Van Buren Township Planning Commission Meeting

**Case 23-031 – Ashley Crossroads
Distribution Center North 11 (Phase 2)
Site Plan and Special Use Review**

Case 19-037
Hampton Manor
Site Plan Amendment Request

Planning Consultant Report

Exhibit 2-16. Minimum Turning Path for Interstate Semitrailer (WB-20 [WB-65 and WB-67]) Design Vehicle

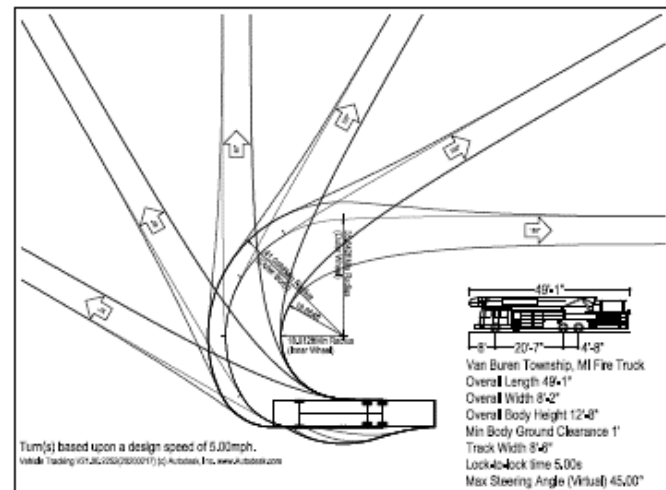
TRUCK CIRCULATION NOTES:

1. TYPE OF TRUCK TRAFFIC WILL VARY, FROM SMALL SINGLE AXLE BOX TRUCKS TO INTERSTATE SEMI-TRAILER, FOR THE CIRCULATION PLAN THE INTERSTATE SEMI-TRAILER WAS USED.
2. THE ESTIMATED VOLUME OF TRUCK TRAFFIC WILL BE 100± SEMI-TRAILERS PER DAY.

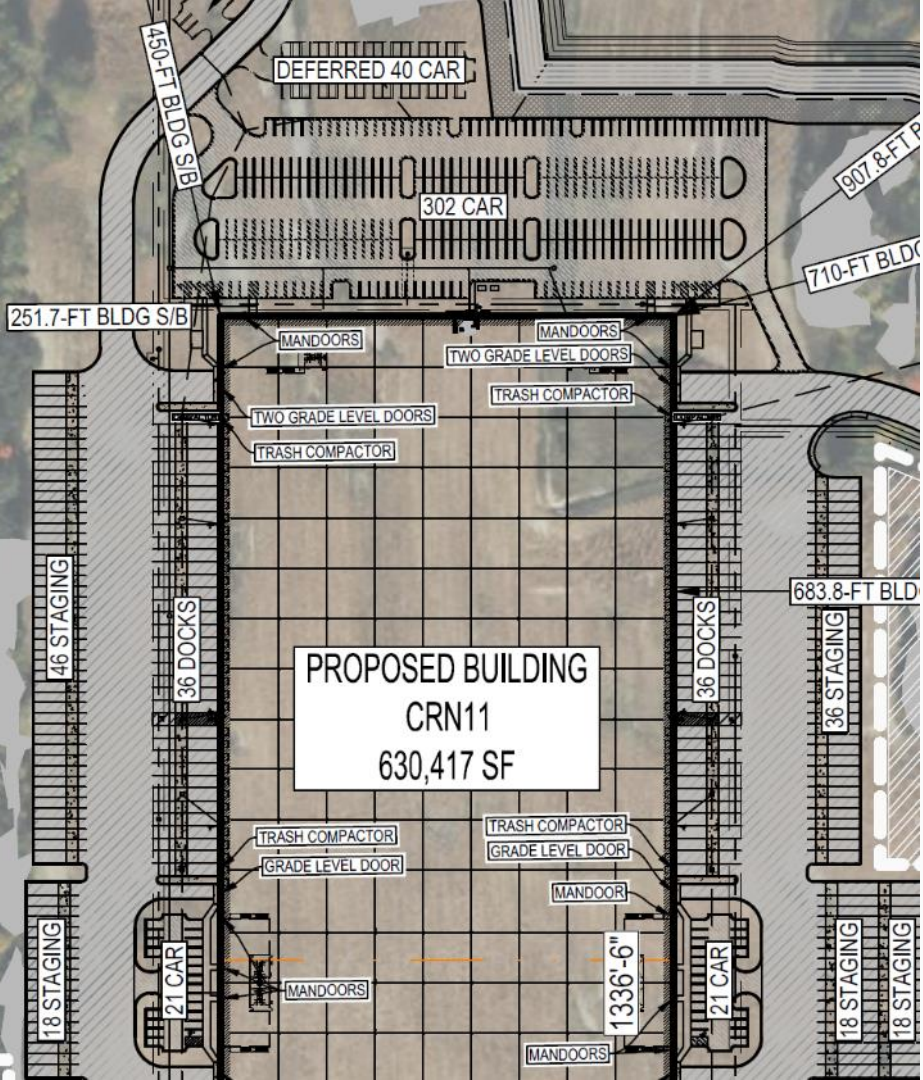
Land Use	Measurement	Required
Distribution Center	5 + 1 per 1,500 sq ft. of GFA (550,617 sq ft.)	372
Office (Distribution Center cont'd)	1 per 350 sq ft. Of UFA (79,800 sq ft.)	228
Loading (Commercial/Industrial buildings over 50,000 sq ft.)	3 + 1 per 50,000 sq. ft. over initial 50,000 sq ft. (630,417 sq ft. total)	15
Total Parking Required: 600 (372 + 228) Maximum Allowed: 720 (600 x 0.2) Parking Provided: <u>470, including 40 deferred parking spaces.</u> Loading Provided: 136 docks, incl. 8 trash compactor docks, and 277 staging areas – <u>clarify 14-foot overhead clearance</u>

Since our last review, the applicant has reduced the parking provided which is now below the required minimum, whereas previously, excessive car parking was a point of concern. The developer has explained that a single prospective tenant would utilize over half of the building area, requiring additional staging areas but only 75 car parking spaces. The developer further explains that, in addition to the deferred parking, the site's staging areas could be converted into car parking, if needed. The Planning Commission has the flexibility to determine if the developer's explanation is sufficient to permit the

deferred parking and staging area conversion in lieu of the required minimum car parking required by Ordinance. An agreement stating the conditions of deferred/converted parking is subject to review and approval by the Township Attorney.

EAST ELEVATION
Approved Elevation

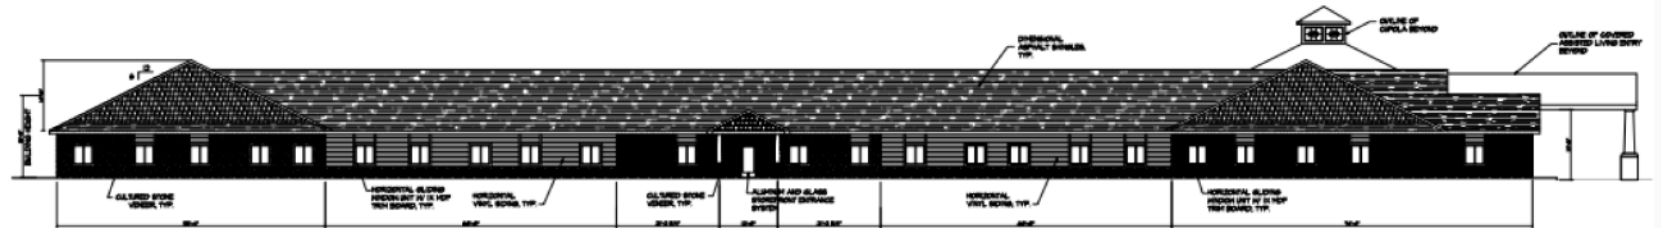
East Façade. The east facade does not match the elevation approved by the Planning Commission.

- The limestone sill/foundation with face brick has been eliminated.
- The areas with brick have been replaced with siding but are to be covered with cultured stone in an attempt to match masonry amount to the approved plans.
- All of the roof dormers have been eliminated.
- The horizontal composite siding in the roof pitches has been eliminated.
- The entrance door accented by columns and a pitched roof feature has been minimized to appear like a utility door with a small roof overhang.

Proposed Correction

Approved Elevation

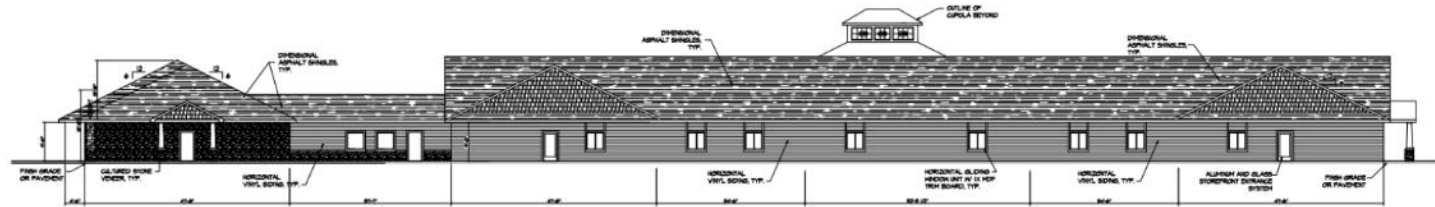
West Façade. The west façade does not match the elevation approved by the Planning Commission.

- The limestone sill/foundation has been eliminated.
- No metal roof accents on the dormers.
- All of the brick and limestone in the approved façade has been replaced with cultured stone.
- Four roof dormers have been reduced to two dormers of a different design.
